APP. EXHIBIT# 1
CASE: 2025-0099-✓
DATE: 11/4/25

LETTER OF EXPLANATION

543 POINT FIELD DRIVE,
MILLERSVILLE, MD 21108

CONFIRMATION OF PRE-FILE

EXISTING SITE PLAN

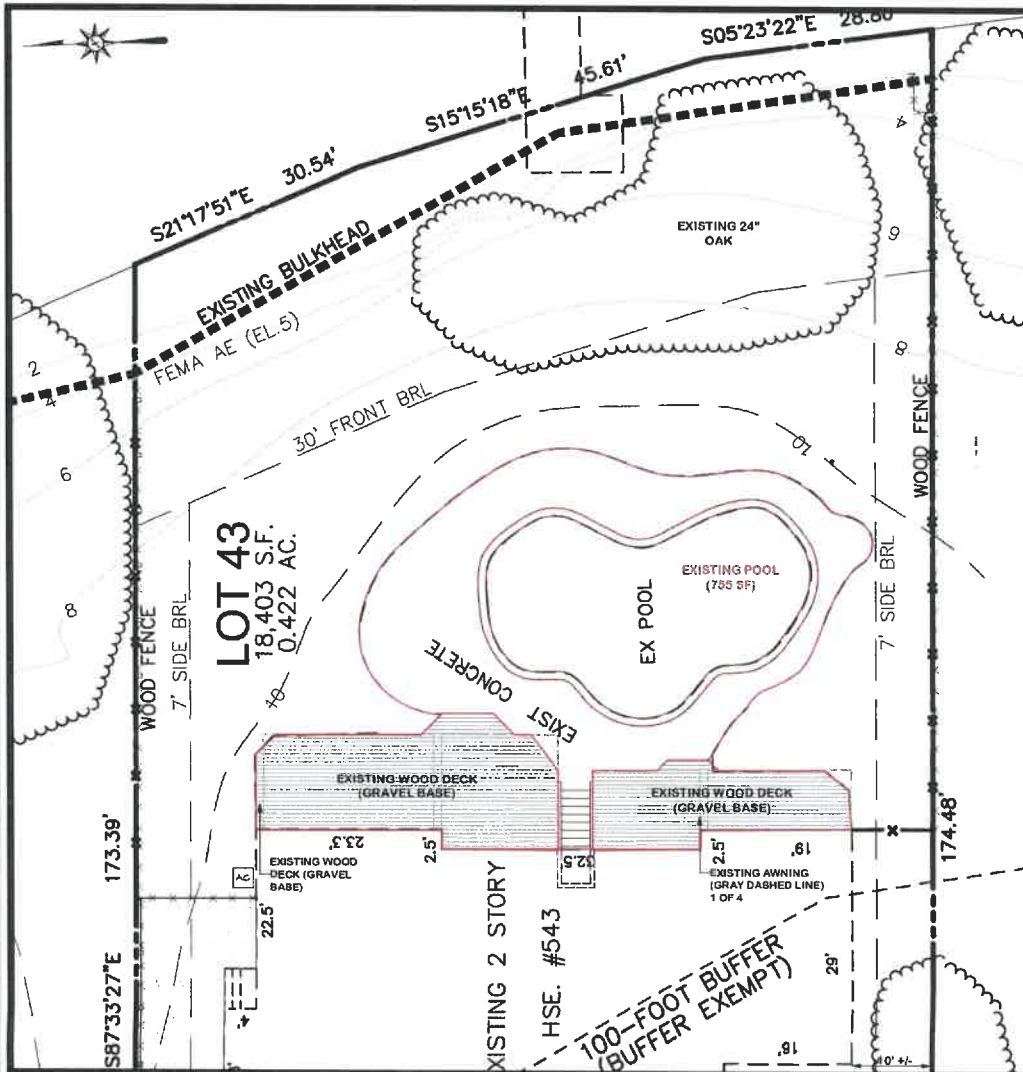
1. Label what is to be removed on the existing plan sheet (i.e., retractable awning, concrete, wood deck, etc.).
2. Expand the limits of disturbance to include access for vehicles and machinery from the driveway to the construction area.
3. Show any existing stormwater management devices and what is to be done with them.
4. Show any proposed stormwater management devices.
